SAFETY BULLETIN

RISE: ORBITER

SUBJECT: CAR ATTACHMENT PINS

BULLETIN NUMBER: 00120

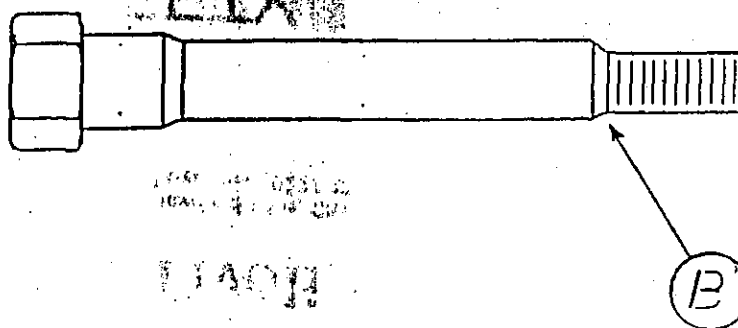
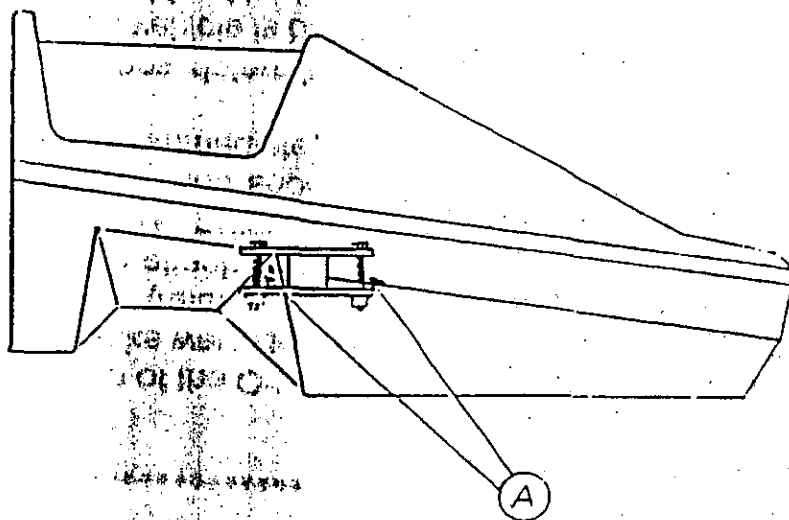
Through routine inspection of the Orbiter Amusement Ride seat attachment pins, (refer to Point A) cracks were detected in the area where the threaded portion meets the pin shaft (refer to Point B). It is recommended by Tivoli Enterprises that these seat attachment pins be inspected by an approved non-destructive testing (NDT) process to determine condition of pins. If cracks are detected, these pins should be replaced immediately. This inspection should be done immediately and then on an annual basis.

After investigation, Tivoli has determined that cracking of pins is due to excessive tightening when vehicle is being attached to sweep. As stated in the manual, these pins should not be tightened in excess of 70 foot pounds. The ride is supplied with an electrical impact wrench which is to be used only to speed the operation of installing and removing these pins. If abused, excessive tightening could damage pins. Use impact wrench to bring pins down until it meets the base metal only.

If it is in owner's or inspector's opinion that use of this impact wrench is being abused by the operator, it is recommended by Tivoli that the electric wrench be replaced with a 3/4" drive ratchet hand wrench.

Drawing: ORSA002A

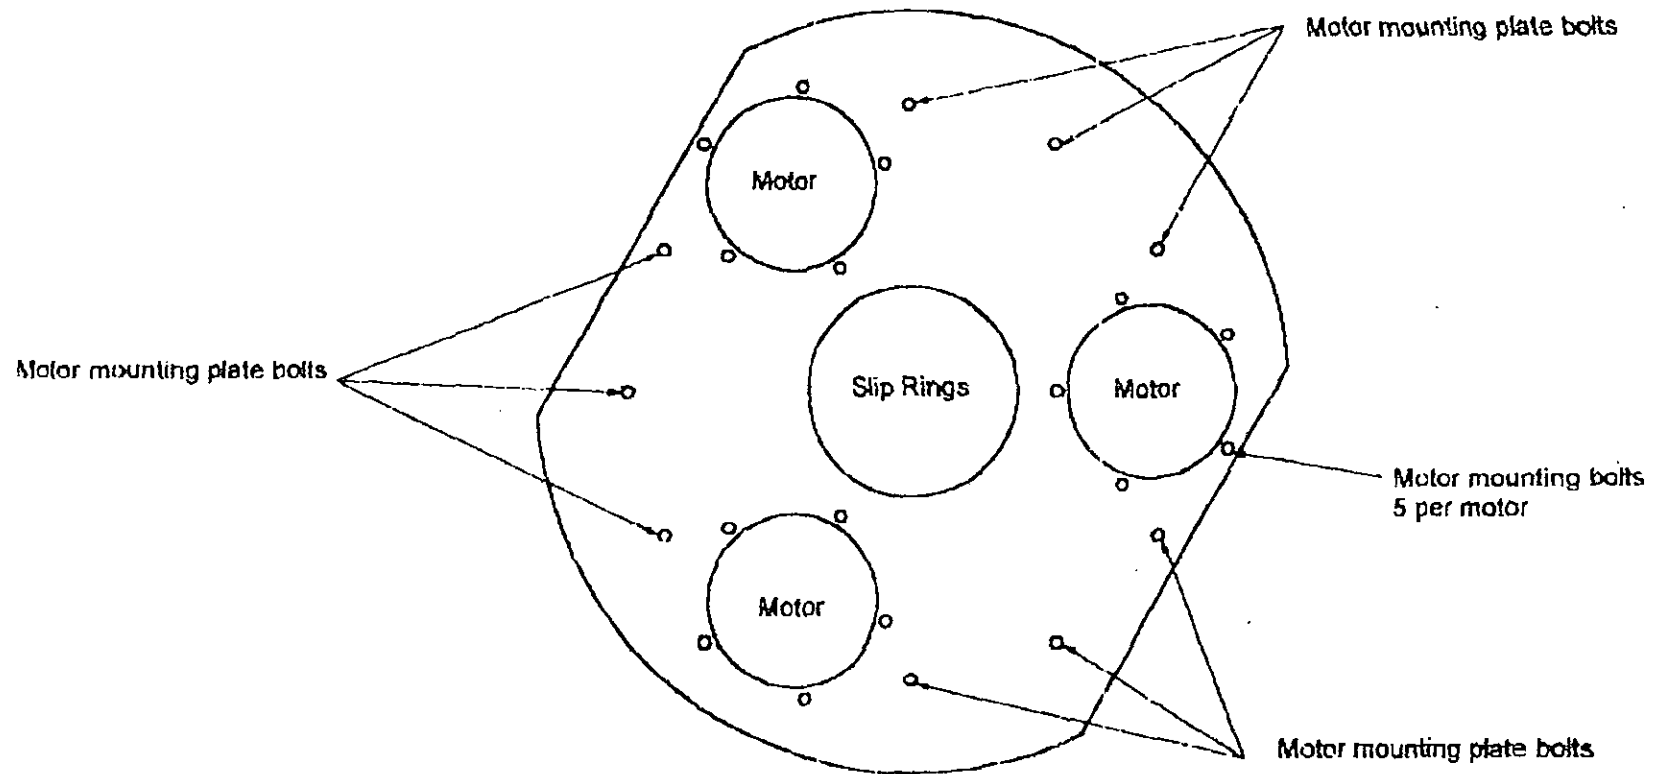
- 9 – 12mm x 45mm bolts spread equal distance around outside parameter of plate. See Attached drawing ORSA002A.

Bolt Specification, three motors and motor mounting plate.

Bolt: Hex head, 12 mm x 45 mm x 1.75, grade 8.8, partial thread, black finish. Ref: DIN 931 / ISO4014

Washers: 12 mm, flat hardened washers, 13 mm ID, 24 mm OD, 3 mm thick. C45. Ref: DIN 6916

Tightening Torque Requirements: Tighten bolts to 65 ft / lbs.

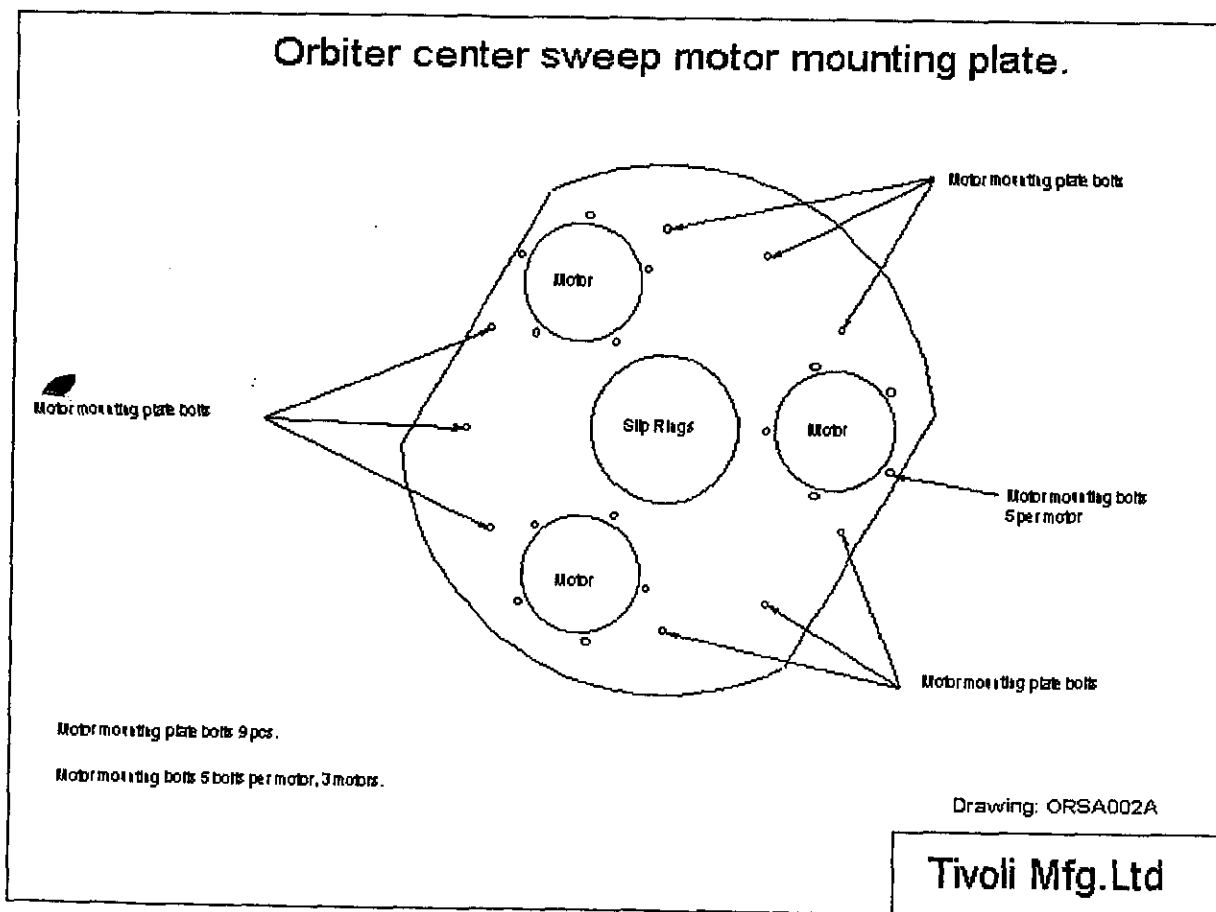
- **Replace all nine (9) bolts securing motors mounting plate to hub.**
 - 9 – 12mm x 45mm bolts spread equal distance around outside parameter of plate. See Attached drawing ORSA002A (See Attached)

Bolt Specification for three motors and motor mounting plate.

Bolt: Hex head, 12 mm x 45 mm x 1.75, grade 8.8, partial thread, black finish. Ref: DIN 931 / ISO4014

Washers: 12 mm, flat hardened washers, 13 mm ID, 24 mm OD, 3 mm thick. C45. Ref: DIN 6916

Tightening Torque Requirements: Tighten bolts to 65 ft-lbs.

Vehicle Connection Frame

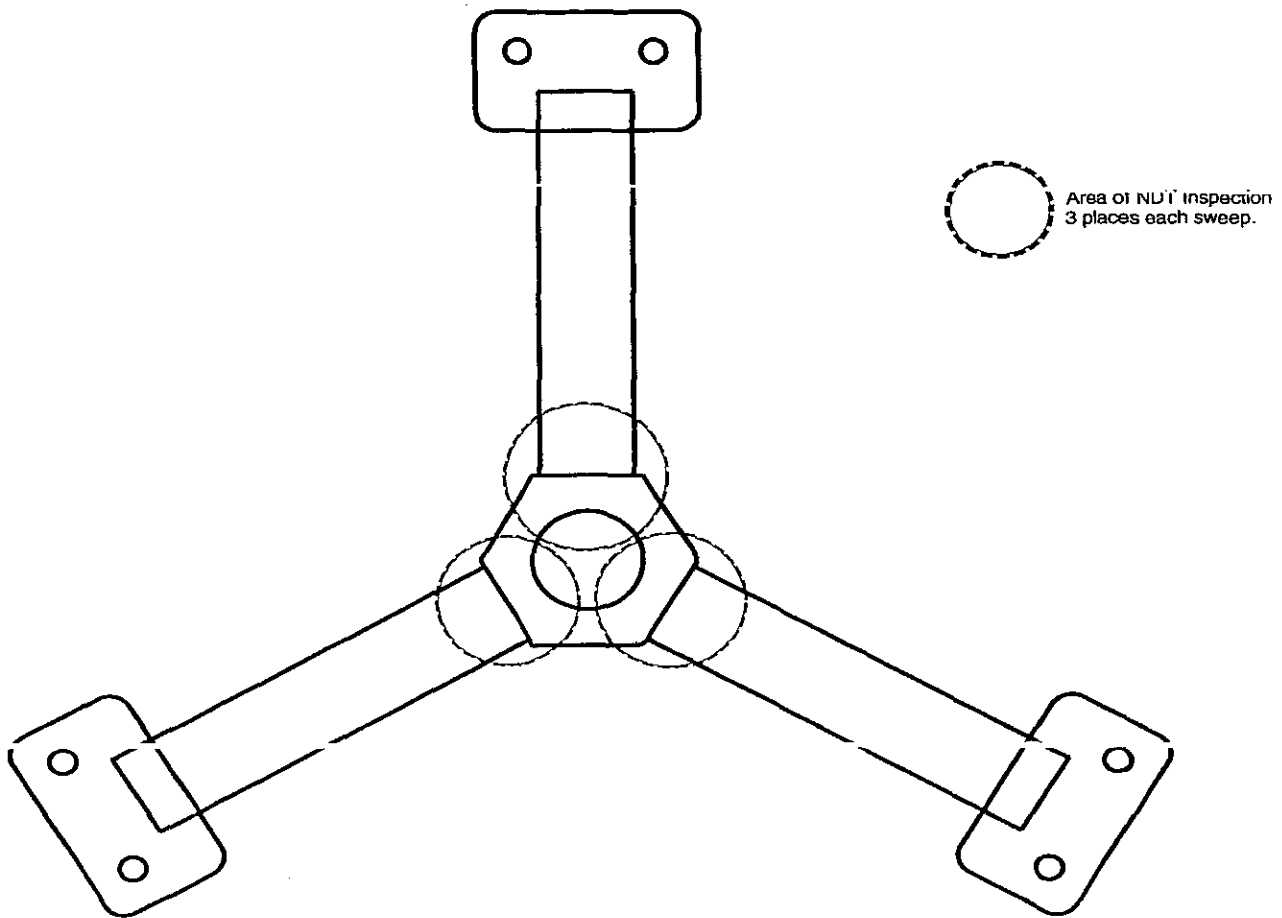
The cause of the separation of the vehicle was caused by a combination of corrosion and cracking of the welded tubing at the weld joint of the attachment frame as indicated in the accompanying drawing.

Tivoli requires that the welded connection and tubing in the area noted in the drawing be tested by magnetic particle NDT testing and visually checked for corrosion. Any additional testing or change in procedure will be at the discretion of the testing technician.

Fig 1: General view of the seat retaining bolt in position on the ride.

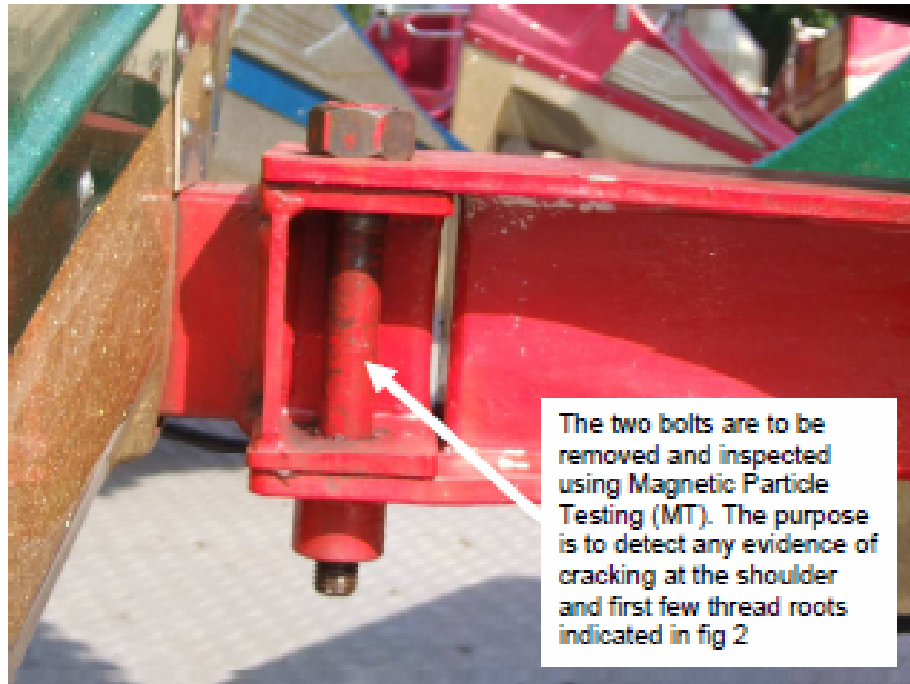
- A. Retaining bolts and surrounding material attaching the seat modules to the three legged spider fabrication.

The following locations around the ride assembly shall be inspected on an annual basis by a certified NDT operator using the specified NDT methods and concentrating on critical locations highlighted in this section.

Fig 4: View of the welded fabrication attaching the three legs holding the seat assemblies to the slew ring (later design).

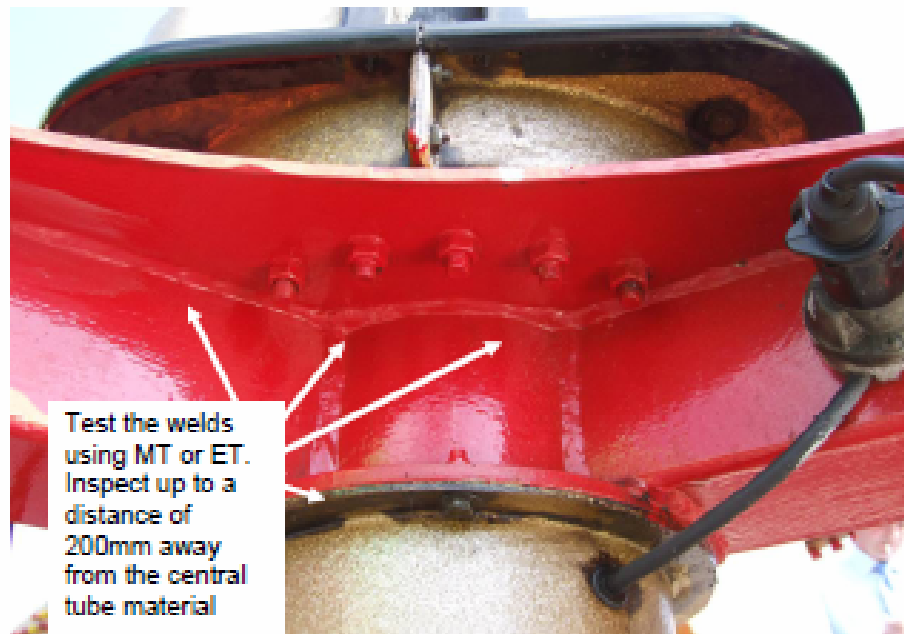
B. Welded fabrication attaching the three legs to the slew ring assembly (later design).

Note: This later design is reinforced by adding a profile cut plate fully welded across the top edge of all three box section legs.

Fig 5: Magnetic Testing of the pin.

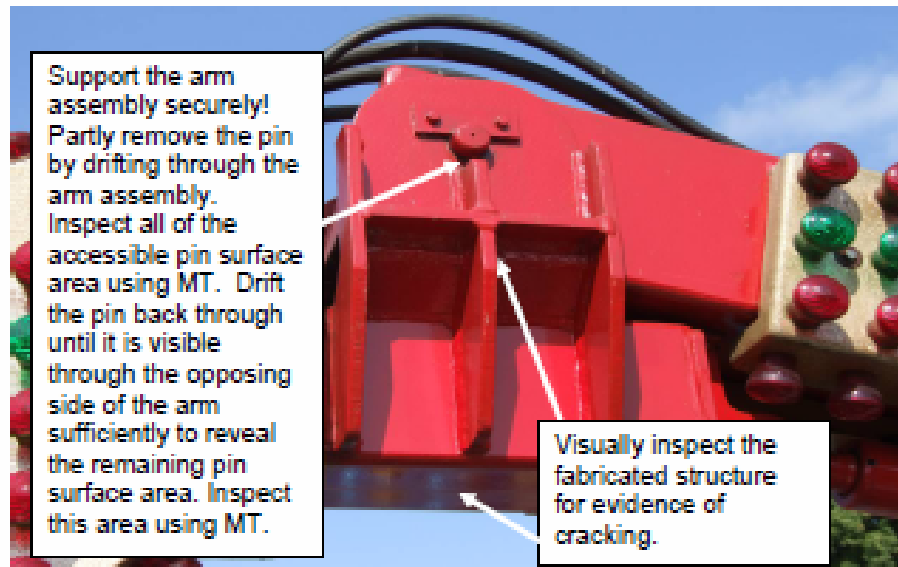
C: Articulating arm connecting pins and hydraulic ram mountings.
